NATIONAL GAMES SECRETARIAT

Corrigendum No.2

Name of Work : Design, manufacturing, supply, installation, testing and commissioning of Flood lighting system at University Stadium, Thiruvananthapuram

Tender No. : 40/NGS/2013-14 dated 13.08.2013

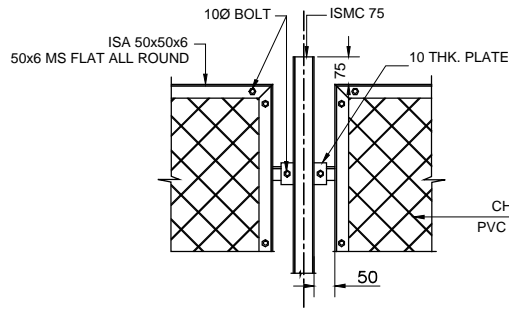
15	Kindly provide detailed single line diagram of the DG synchronization panel	The single line diagram will be enclosed with this document
16	<p><u>Bill of Quantities</u></p> <p><u>Sl. No. 1:</u> Kindly provide details of chain link fencing required for each mast. Min. Ht of the mast should be 46mtr at the centre of the head frame if IAAF guideline is to be followed. NIT specifies minimum height as 40mtr @ centre of head frame. Kindly confirm the requirement.</p> <p><u>Sl. No. 8:</u> Kindly specify the voltage drop limit for determining the cable sizing. (Normally for trouble free striking of the metal halide lamp it is advisable to limit the voltage drop within 3% at the fixture end.)</p> <p><u>Note no. 5:</u> Kindly clarify whether the payment for items defined as "1 job" or "LS" shall be limited to amount quoted or shall be made as per actual quantities installed.</p>	<p>The drawings of chain link fencing are enclosed with this document.</p> <p>It is clarified that, While quoting, the Min. height of the Mast shall be as per the clause no. 5.1.4.2 of IAAF track and field facilities manual 2008. The bidder can provide more height if their design warrants so, without additional claim from NGS</p> <p>It is already mentioned in the section 2.7 of technical specification that, while selecting the cables, voltage drop should not exceed 3 %.</p> <p>Payment for items defined as 1 job" or "LS" shall be limited to amount quoted.</p>

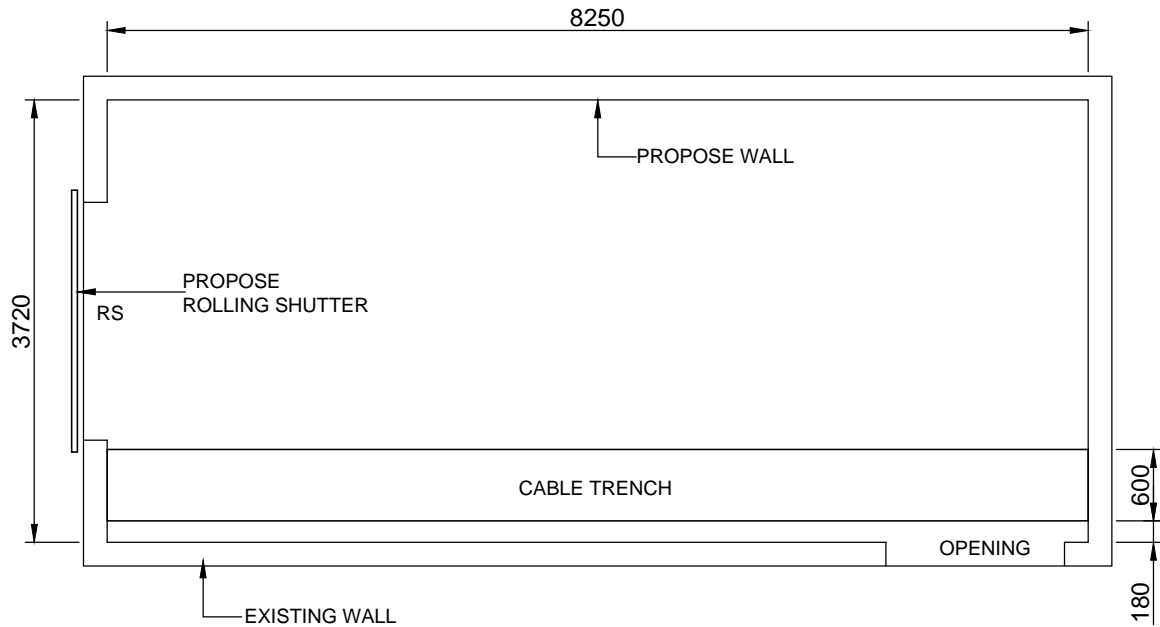
11	Please confirm the location for Main Panel (DG Synchronization Panel). This is required to estimate lengths of cables from the same to each High mast panel.	The drawing indicating the location is enclosed with this document.
